AMPEX

professional
products division**SERVICE BULLETIN**

Date: 14, March 1960
 Model: General
 Bulletin No: Index
 Page No: 1

New No.	Old No.	Date of Issue	Subject	Remarks
				5/19
3-01	1	20 Jan. 1958	Gate Springs	✓
4-01	3	31 Aug. 1954	Replacing Heads	✓
5-01	4	25 Mar. 1955	Turntable Height	NO
5-02	5	18 Nov. 1959	Capstan Idler Adjustment	✓
	6		Obsolete	
5-04	7	18 Nov. 1959	Tape Tensions	✓
6-01	8	12 July 1956	Head Cleaner	✓
	9		Obsolete	
	10		Obsolete	
6-02	11	6 Sept. 1956	Turntable Pin	✓
7-03		3 Feb. 1959	Dummy Erase	✓
8-01	12	3 Mar. 1958	Aligning Heads	✓
8-02	2	6 Mar. 1958	Held Down Knob	✓
8-03	14	1 Aug. 1959	High Output Microphone	✓
8-04	13	19 Mar. 1958	Scales	✓
8-05		22 Dec. 1958	Signal-To-Noise	✓
8-06	15	16 Feb. 1959	Ampex Master Equalization (AME)	✓
9-01		14 May 1959	Torque Adjustment	NO
9-02		2 June 1959	VU Meter	✓
9-03		20 Oct. 1959	Brakes	✓
9-04		7 Dec. 1959	Drive Motor Springs	✓

TITLE ALTERNATE POWER INPUT CIRCUIT
PART NUMBER 4020251-04 REVISION

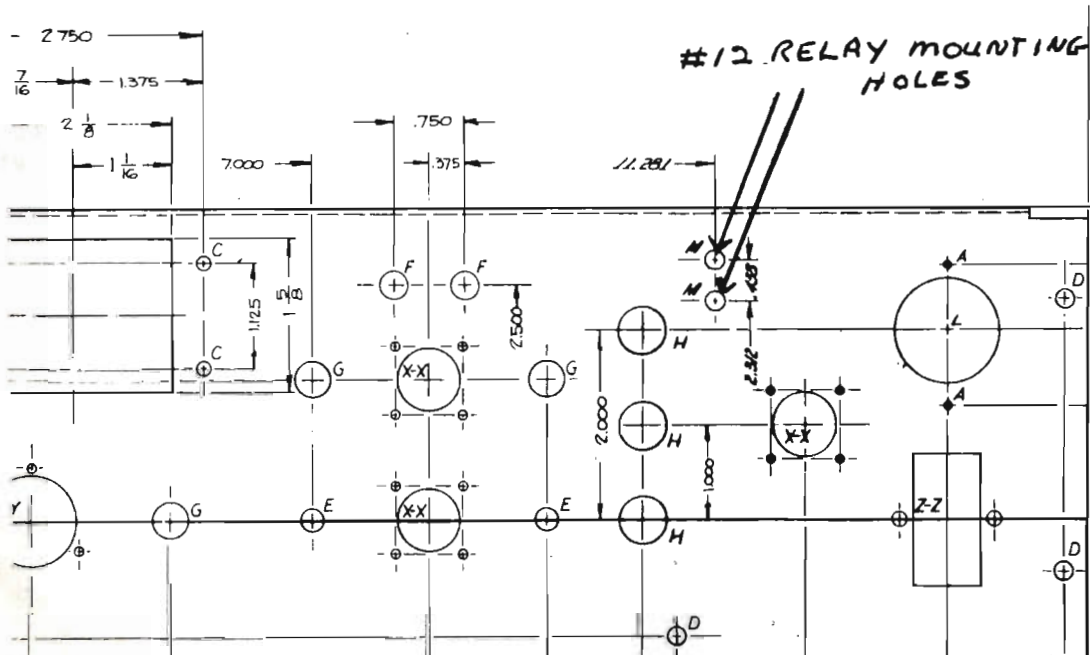
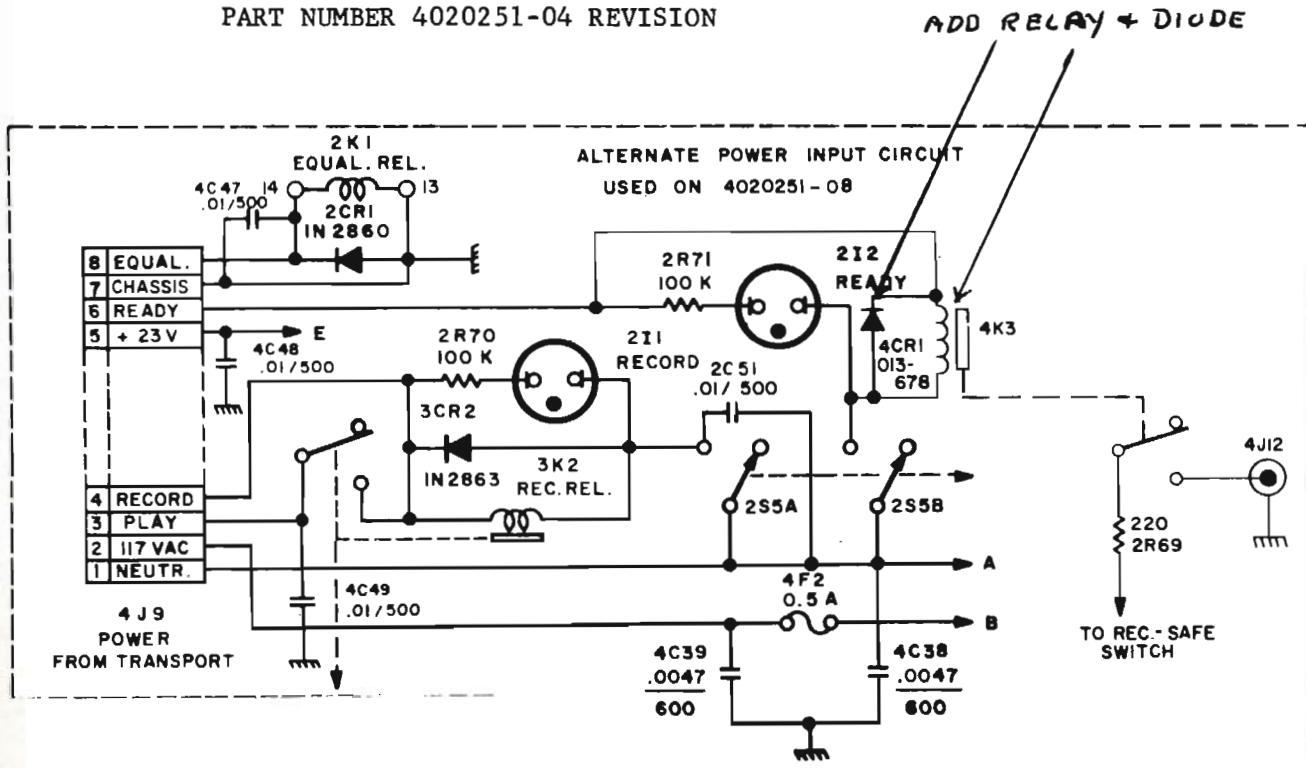
To prevent the possibility of erasure during certain modes of operation.

When operating in the Sel-sync mode the Rec-safe switch does not always prevent erasure of the tape.

Remove the rear panel assembly and drill two holes located per the attached drawing. Mount the relay on the rear panel and connect the relay and diode in accordance with the attached schematic.

FIG. 1

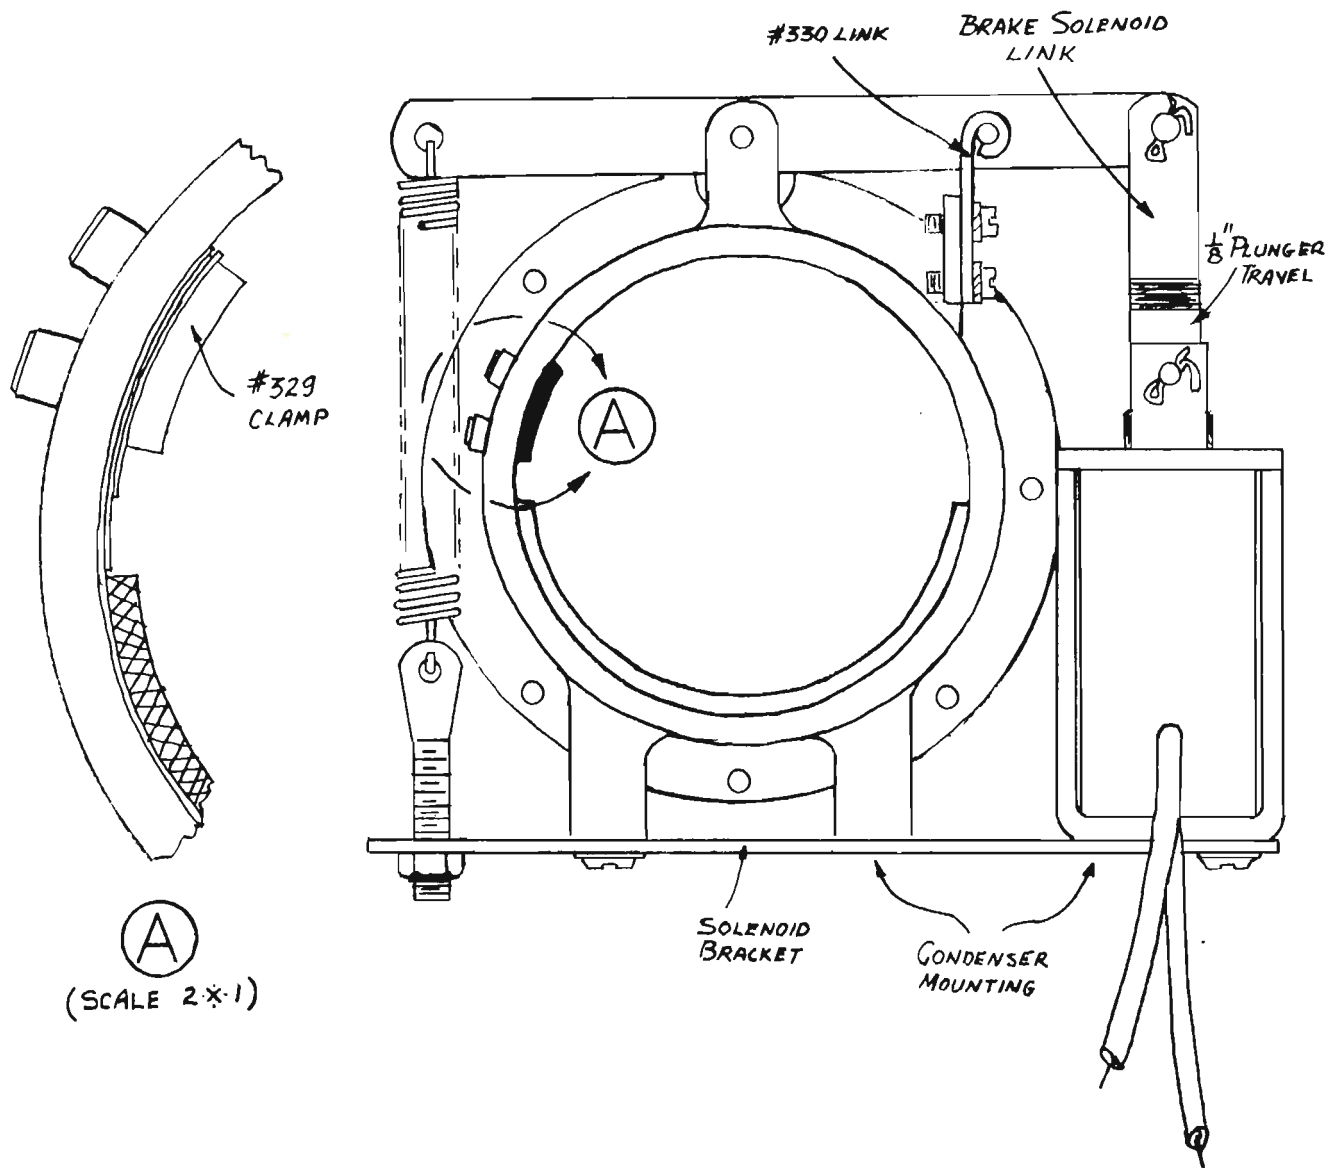
Two different designs of Brake Assemblies have been used on the Model 300 and Model 350 Series Recorders. The earlier design, which was discontinued on production models of the 300 Series and 3200 Series during 1956 and the 350 Series on August 1, 1959, is shown in Figure I.

This design used graphited felt brake bands and one brake tension spring which is adjustable to maintain proper brake tension settings.

If the brake linings are too badly worn to respond to this reconditioning procedure or if the brake band is broken, it is necessary to replace the brake band assemblies which are available in sets of two. Order Kit #7970-01.

FIG. 2

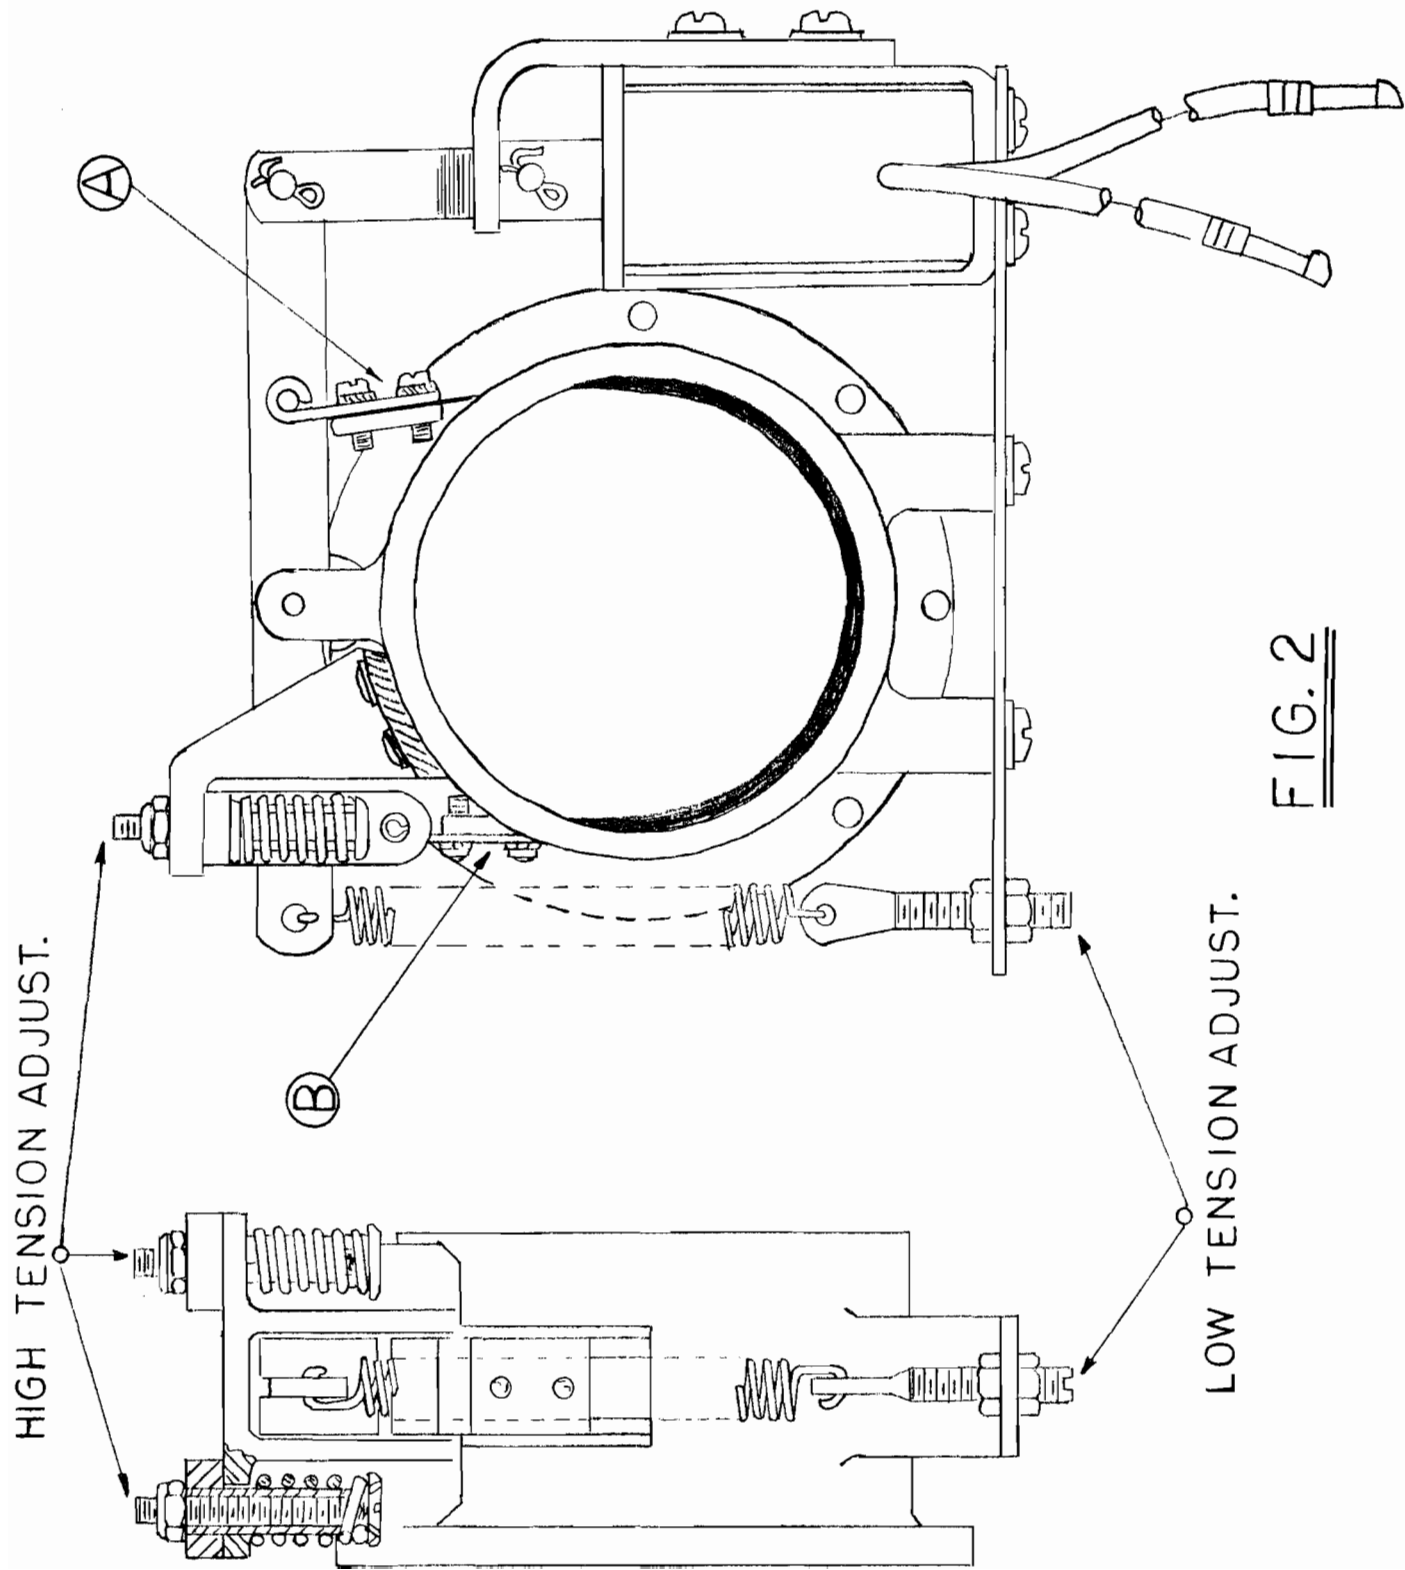
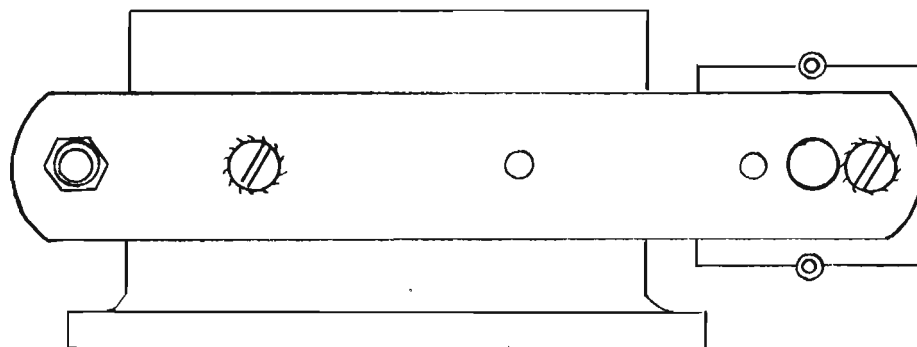
The new brake assembly shown in Figure II is currently used on production Models 300, duplicator and 351 series recorders.

This design uses a Raybestos brake band with two adjustment points to maintain proper brake tension settings. To replace the older brake assemblies with the newer version simply order by Ampex catalog number below:

<u>TAPE WIDTH</u>	<u>ASSEMBLY</u>	<u>CATALOG NO.</u>
1/4 inch	Takeup	17327-1
1/4 inch	Rewind	17327-2
1/2 inch	Takeup	17327-3
1/2 inch	Rewind	17327-4
1 inch	Takeup	17327-5
1 inch	Rewind	17327-6
